Appl. No. 10/065,169 Amdt dated February 6, 2004 Reply to Office Action of November 06, 2003

# REMARKS AND ARGUMENTS

FIG 1 PRIOR ART

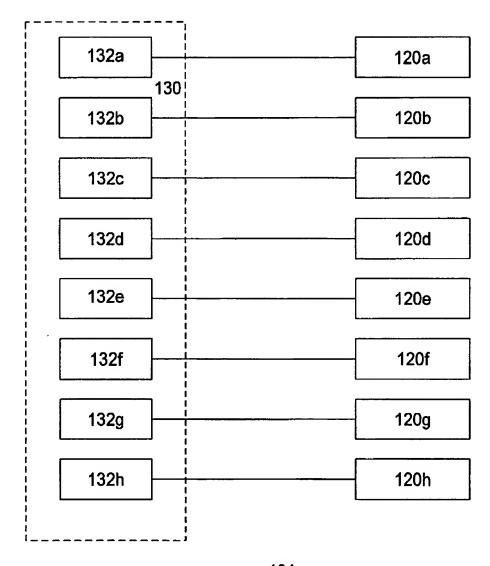
Figure 1 has been objected to by the Examiner. Specifically, Figure 1 should be designated by a legend "Prior Art" because only that which is old is illustrated. Applicants, in response, have amended Figure 1 as suggested by the Examiner. Applicants therefore submit that the objection to the drawings has been traversed.
